## ASSESSMENT REPORT

### Taronga Institute of Science and Learning, Taronga Zoo Section 4.55(1A) Modification Application SSD 7311 MOD 1

Figure 2: The proposed solar panels and already installed hot water panels (source: Applicant's EIS)

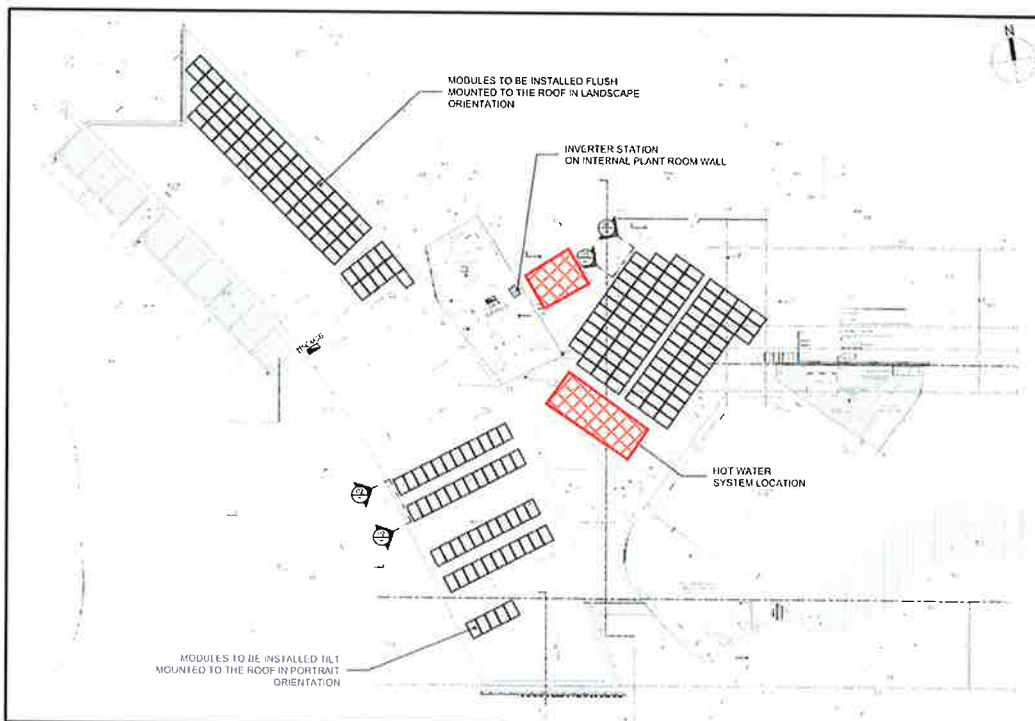
The Applicant has advised that the 12 hot water panels have already been installed (shown by red hatching in **Figure 2**). The Applicant therefore seeks to regularise these works as part of the proposed modification. Separate compliance action was undertaken concurrently to the modification application in respect to these works. The investigation resulted in a warning letter that was issued to the Applicant on 10 July 2018. No further action will be taken.

Council did not object to the modification application but recommended the solar panels be located to reduce the visibility from the harbour and surrounding headlands. The Applicant noted this concern in the Response to Submissions (RtS) and confirmed the majority of the panels would be sited on the north-eastern facing roof areas where they are invisible from the harbour due to the sloped roof.

Figure 3: Looking south-west towards the facility from Taronga Zoo car park  
(Source: Department's Photograph)

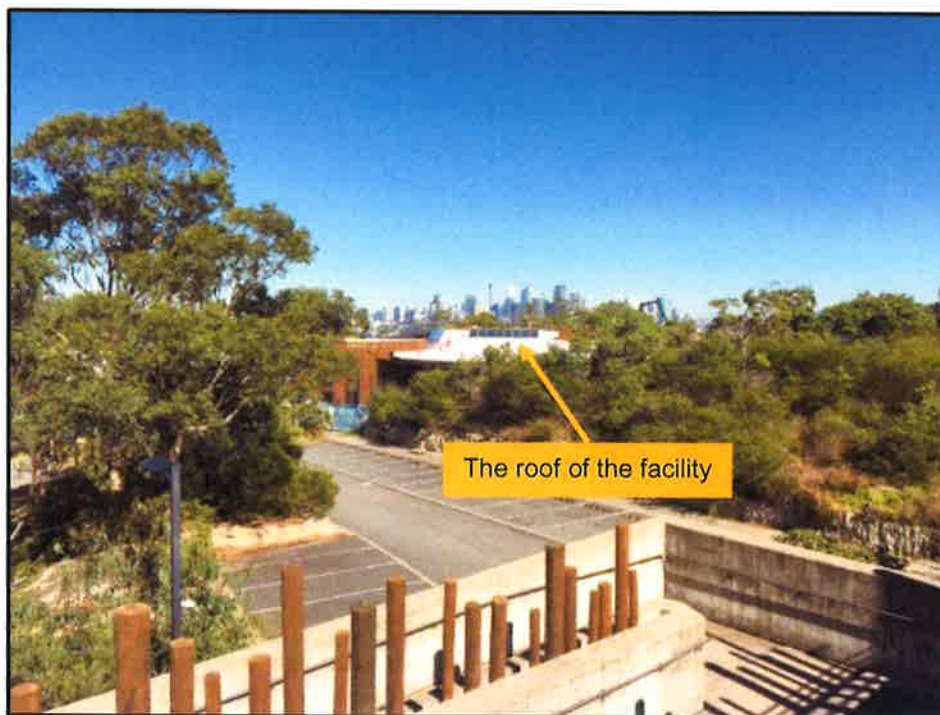
Council recommended the panels be located to minimise their visibility from the harbour and surrounding headlands. To reduce their visibility, 51 panels will be tilted at 30 degrees and the remaining 173 panels will be installed to be parallel or 'flush' with the roof line angle of the facility. The tilted panels will be set between 40 cm and 50 cm above the roof line to maximise the capture of sunlight. No additional infrastructure will be required to operate the panels as they will be connected to existing services at the zoo.

The Department notes the solar panels have a low profile that results in minimal visual impact and minimal additional building height, and the panels to the south-eastern lower portion of the site would be tilted rendering the panels invisible from surrounding residential properties. The panels would also not interrupt significant views to, or from, Sydney Harbour or any item of heritage significance as they are surrounded by significant tree foliage that conceals and obscures the panels when viewed from surrounding residential properties and the harbour (**Figure 3**). All panels would be laminated to reduce the reflectivity to 6.2% reducing the potential for glare and are in keeping with the modern architecture of the facility.

The Department concludes that the proposed solar panels would not have an adverse visual impact on the zoo, surrounding public domain or adjoining residential properties.
